CALIFORNIA ENERGY COMMISSION

November 28, 2011

Subject: AHRI Comments on Residential Zoned Air-Conditioning

Figure 1. Overlay of AC Efficiency (watts cooling/watts energy consumed) in NAHB study

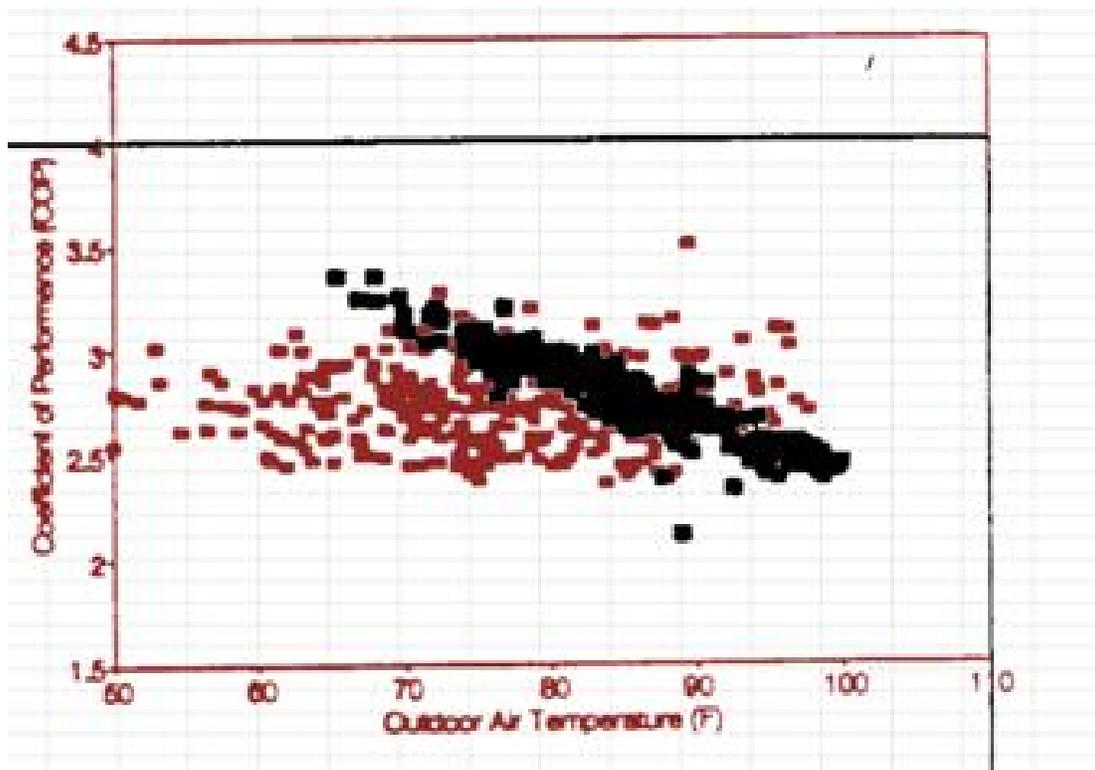
The cooling savings conclusions of the 1994 study are questionable due to two incongruities in the report. First, there is an unexplained, random distribution of air conditioner efficiency against outdoor temperature for the system operated as a whole house (single zone) system. But in the zoned operation, the study shows a typical air conditioner efficiency pattern against outdoor temperature. The reported efficiency of the unit as a whole house system was substantially lower than when operated as a zoned system in all but the highest temperatures. This is shown in Figure 1 (an overlay of the study’s Figures 3.2.2 and 3.2.3).

Second, the report states that “both systems experienced approximately the same percentage of hours in each temperature bin.” However the graphs in the report show vastly different “Typical Record Year” temperature bins — a statistic that should be identical between the two graphs.

Figure 2. Net Zoned System Efficiency with Bypass (Carrier Lab Data)

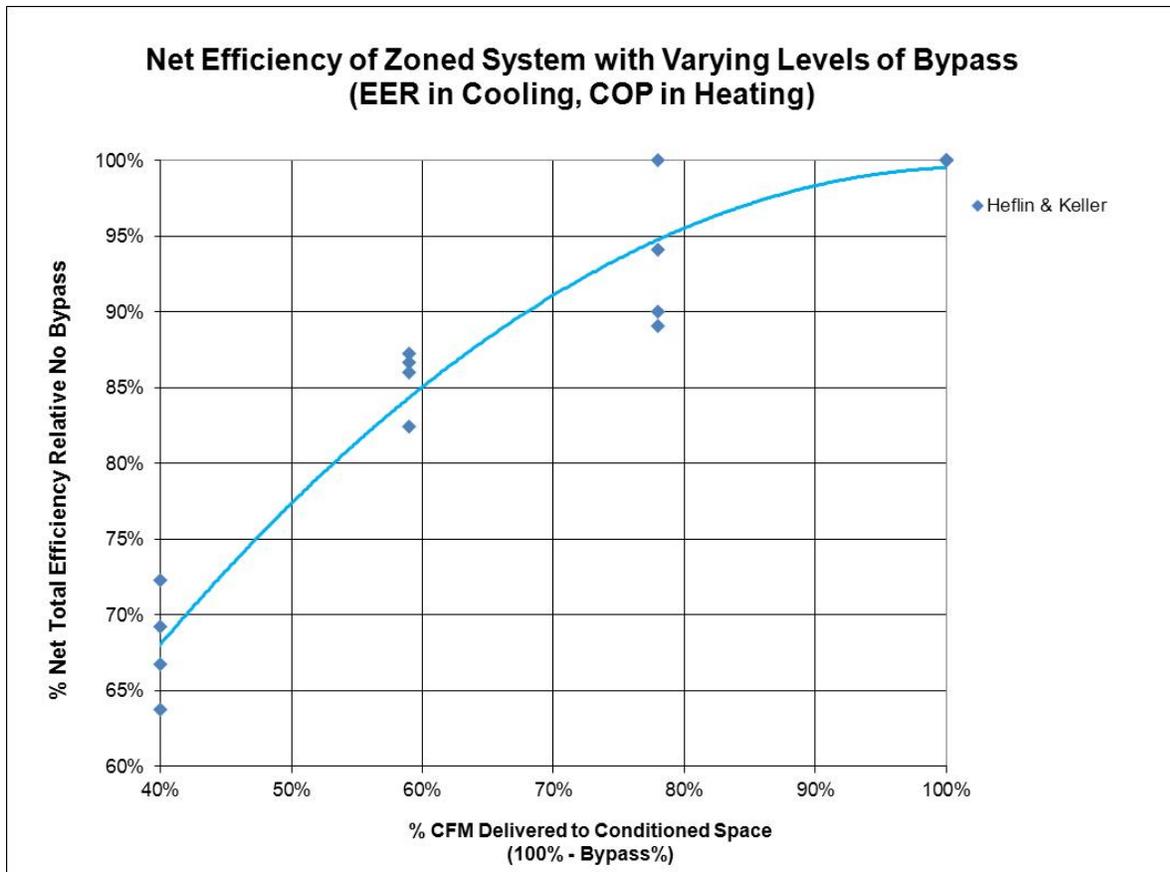
Figure 2 shows the loss of efficiency from recirculating air through a bypass. The left hand axis shows the percentage of efficiency relative to no bypass. The bottom axis displays the percentage airflow providing cooling or heating to the conditioned space. When 50% of the air is bypassed, the efficiency falls to 77% of its full value or a 23% loss in efficiency.

This paper did not present data on the reduction in sensible heat ratio as the amount of bypass increases. It is well known, however, that the recirculation bypass ducts reduce the sensible heat ratio and that the sensible energy efficiency ratio (EER) drops faster than the total EER, as plotted in Figure 2.

Figure 5. ACCA Manual Z Equation Approximates Field Unit 2

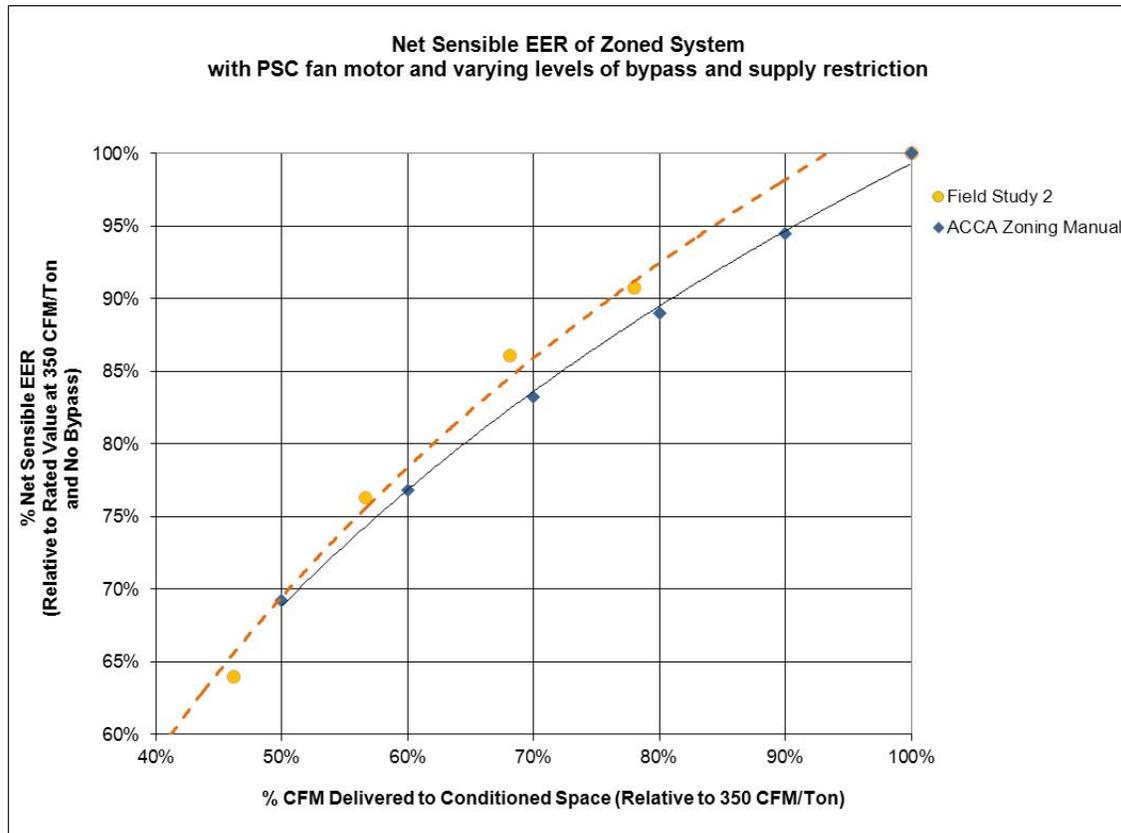
Air Conditioning Contractors of America is producing a manual titled “Zoned Comfort Systems for Residential Low-Rise Buildings” (Rutkowski 2011). The manual, which is currently in a public review draft, includes an equation (Figure 3) for estimating the supply dry bulb temperature based on the bypass factor and other operating conditions. The equation assumes a sensible heat ratio of 1.0, which is not achieved in the field. The result is an overestimate of the sensible cooling delivered to the house. While the equation produces an overly optimistic view of the sensible capacity of an air conditioner operating with a bypass, plotting the results of that equation shows that the reduction in efficiency from a bypass is approximately 31% for a 50% bypass. Figure 4 shows the numbers from that calculation for a 3 ton unit with 1050 CFM through the unit and varying levels of bypass. The results are plotted in Figure 5 and compared to the field data for unit #2.

Figure 7. Normalized Fan Watt Draw Increase with Multi-Zoned HVAC Systems

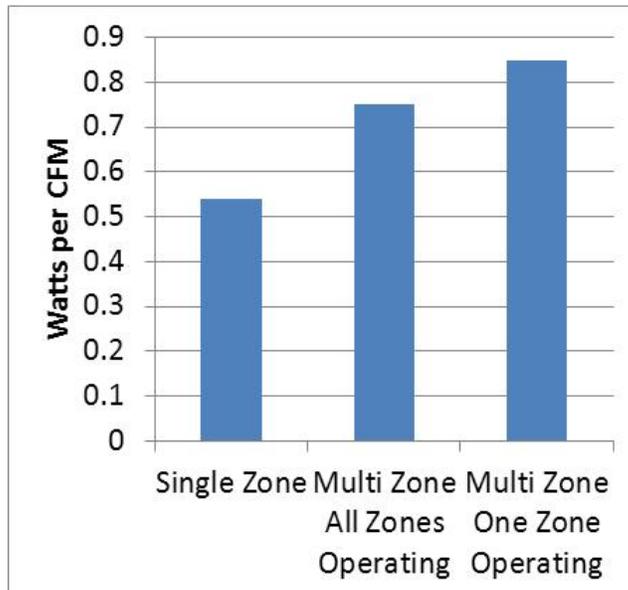
As displayed in Figure 6 and Figure 7, the ECO project found that the multi-zoned systems had significantly lower airflow and higher watt draws than single zoned systems. The differences were always significant at the .05 level. The result of the low airflow and high fan watts is reduced capacity and efficiency (both sensible and total).
